**AGENDA
PLANNING COMMISSION MEETING
CITY OF SHOREVIEW**

A. VARIANCE / RESIDENTIAL DESIGN REVIEW

File No: 2556-14-46

Location: 5280 Oxford Street North

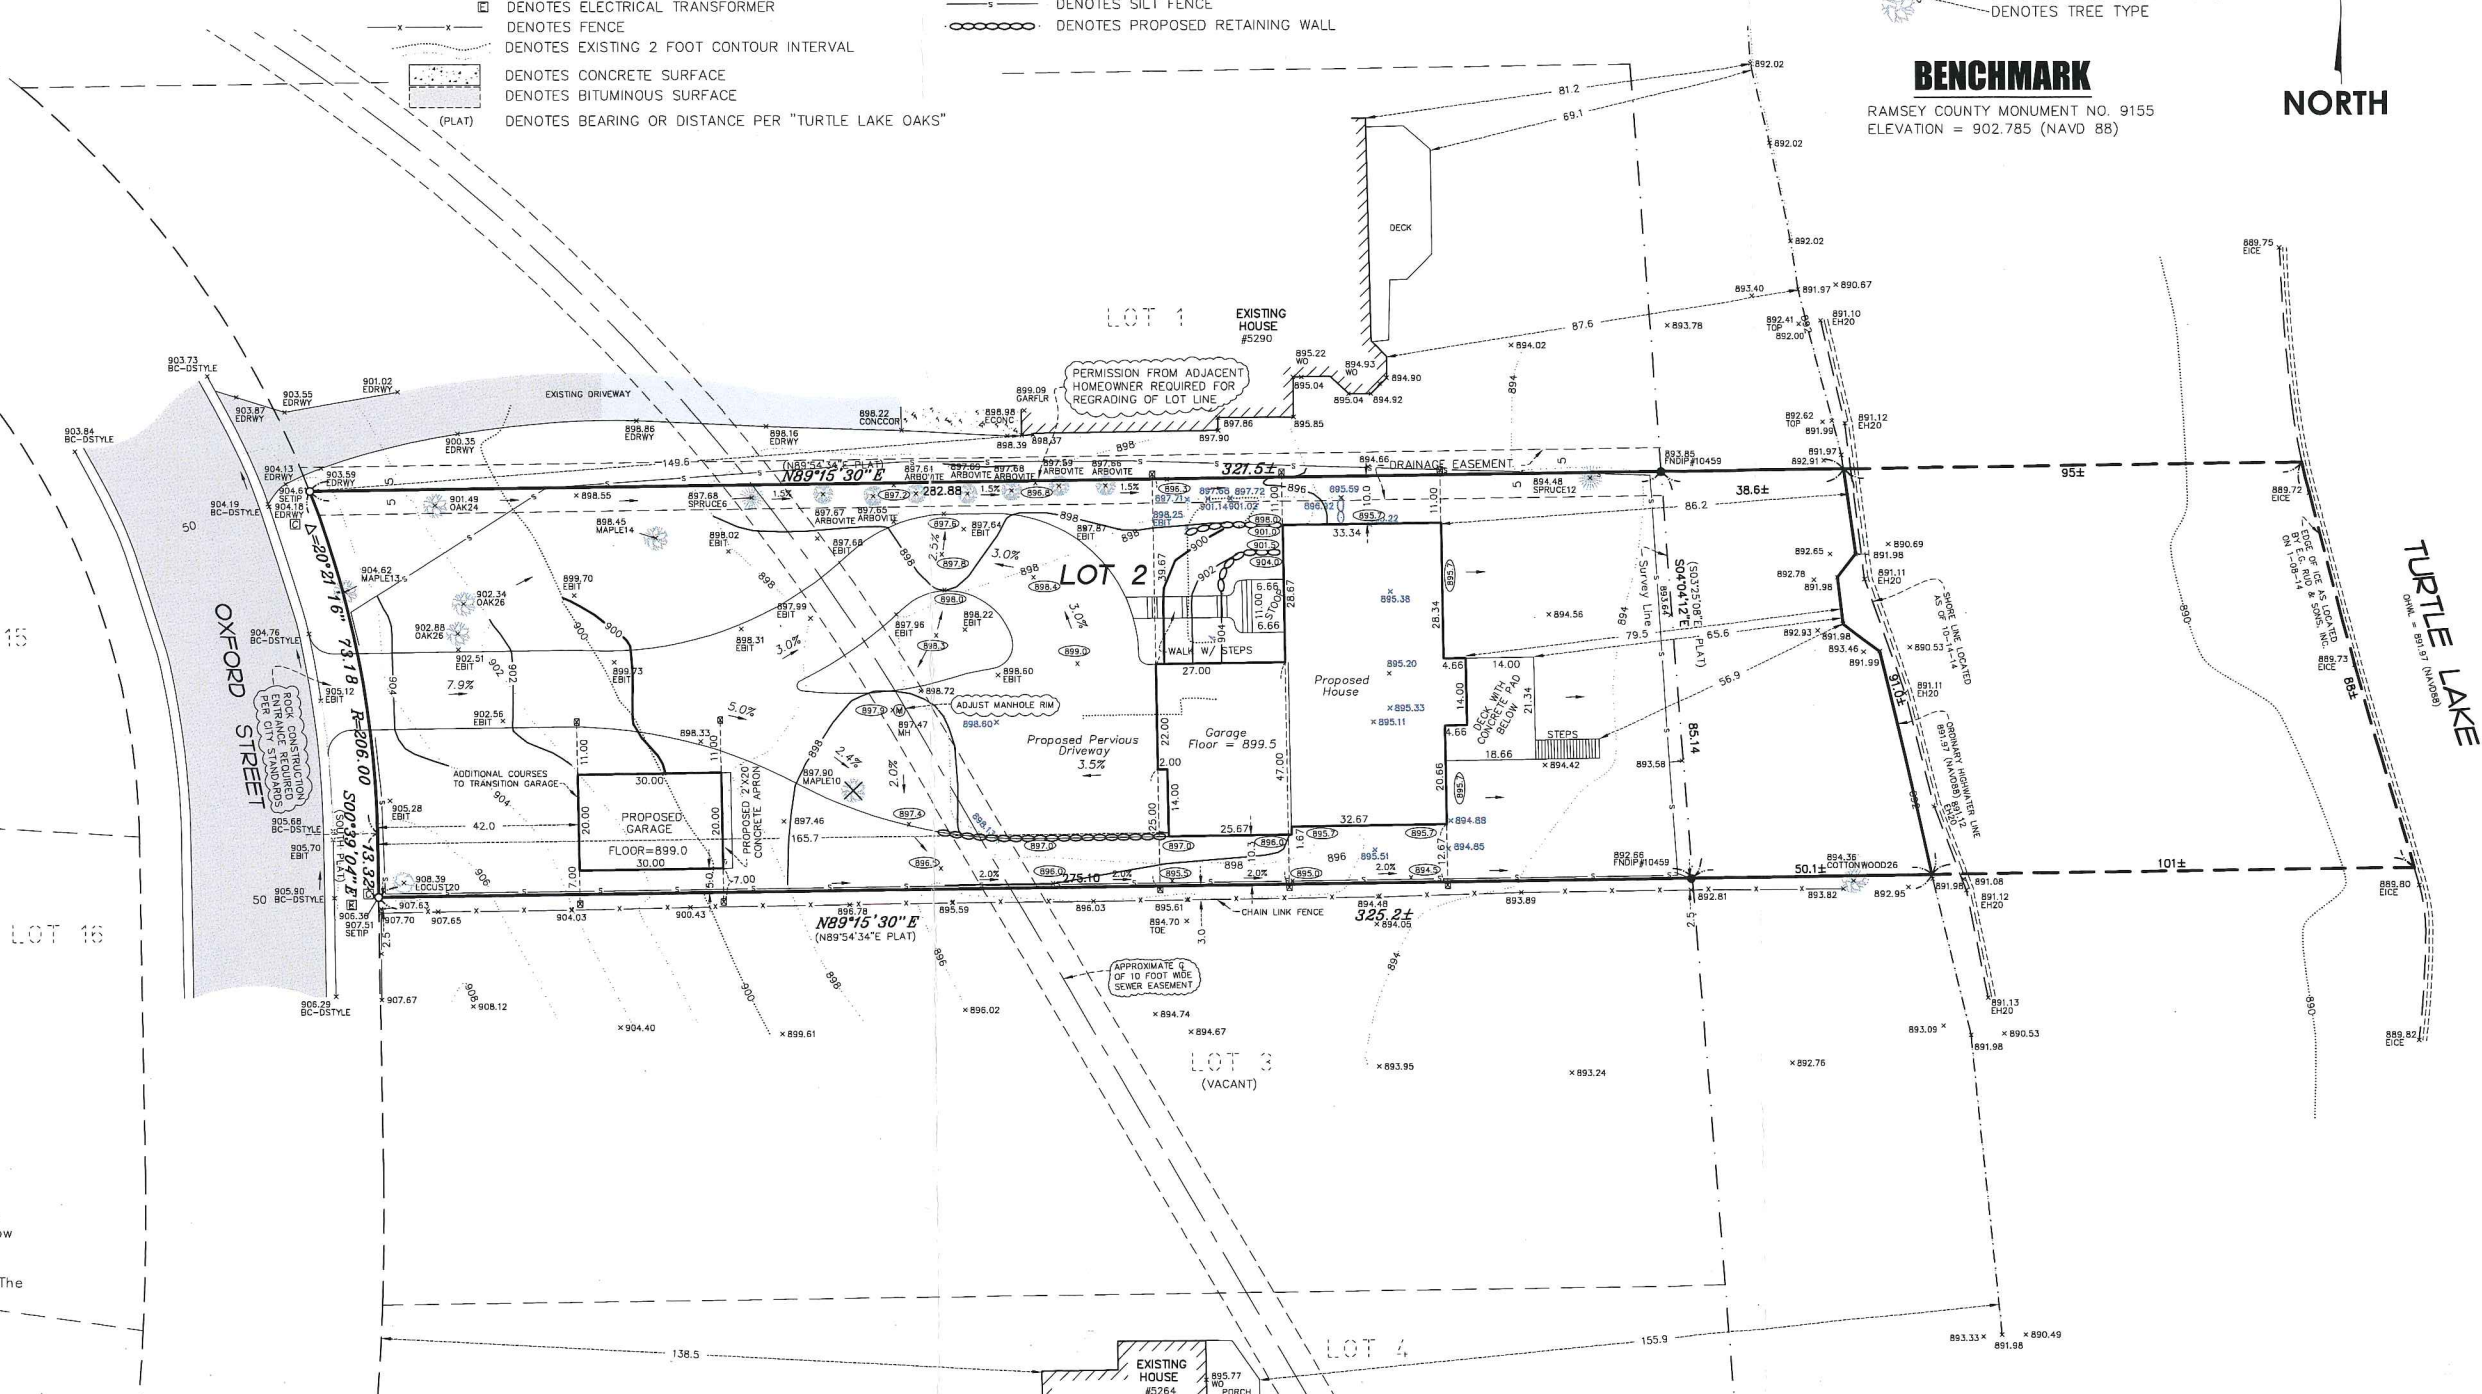
The percent impervious surface for the lot should be calculated on the site plan to include the surface area of the driveway as 100 percent impervious. DNR's policy regarding pervious pavers is that, for percent impervious surface calculations, pervious pavers should first be considered impervious when determining whether a variance for percent impervious surface is required. A reduction in percent impervious surface is not included in the initial calculation because pervious pavers are a form of mitigation for exceeding 25 percent impervious surface, not a way to increase the amount of lot coverage allowed.

Then, based on these calculations, a determination is made as to whether a variance is required. For this lot, the proposed impervious surface calculations should be shown on the site plan as:

Mitigation using pervious pavers should bring the site's impervious surface to 25 percent or less to meet State Shoreland Rules and the City's Shoreland Ordinance. However, even with the 50 percent mitigation credit for the use of pervious pavers for this property, the site plan exceeds 25 percent impervious surface. Under the Practical Difficulties Standard, the size of the driveway in this site plan is driving the need for a variance, not circumstances that are unique to the property.
